Access Compliance Report

Public Rights-of-Way

(Curb Ramps)

Intersection ID: 3159	Main Street: DAUPHINE_DR	Cross Street: MAGENNIS_GROVE_CT	Location:	N
ADA ID: 0A0FF86E696D	Ramp Type: Perp	Initial Pass/Fail: Fail	Overall Compliance: No	Severity Score: 1.25
Codes/Mitigation Info/Possible Solution		Field Measurements/Component Compliance

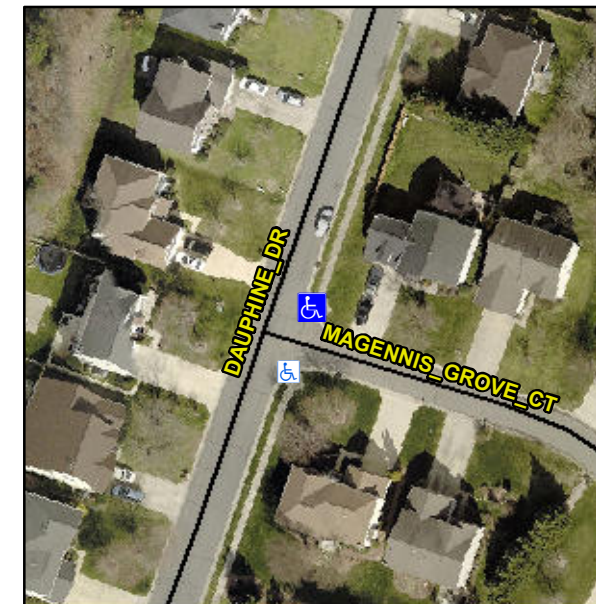
Not Found, R304.5.3

Compliance	Description	Data	Compliance	Description	Data
N/A	Ramp Length (in)	51.0	Yes	Ramp Slope (%)	5.7
Yes	Ramp Width (in)	48.0	No	Ramp XSlope (%)	4.6
N/A	Flare Type LT	N/A	N/A	Flare Type RT	N/A
N/A	Flare Slope LT (%)	N/A	N/A	Flare Slope RT (%)	N/A
N/A	Flare Traversable LT?	N/A	N/A	Flare Traversable RT?	N/A
N/A	Landing Length (in)	N/A	N/A	DWS Provided?	N/A
N/A	Landing Width (in)	N/A	N/A	DWS Contrast?	N/A
N/A	Landing Slope (%)	N/A	N/A	DWS Length (in)	N/A
N/A	Landing X Slope (%)	N/A	N/A	DWS Full Width?	N/A
N/A	Landing Curb? (Y/N)	N/A	N/A	DWS Offset (in)	N/A
N/A	Shared Landing?	N/A			
N/A	Gutter Ponding?	N/A	N/A	Gutter Slope (%)	N/A
N/A	Gutter Lip Ht (in)	N/A	N/A	Gutter X Slope (%)	N/A
N/A	Painted X Walk1?	No	N/A	Painted X Walk2?	N/A
	X Walk 1 Direction	To SW		X Walk 2 Direction	N/A
N/A	X Walk 1 Width (in)	N/A	N/A	X Walk 2 Width (in)	N/A
	X Walk 1 Slope (%)	2.1		X Walk 2 Slope (%)	N/A
	X Walk 1 X Slope (%)	5.7		X Walk 2 X Slope (%)	N/A

Remove & Replace Entire Ramp.
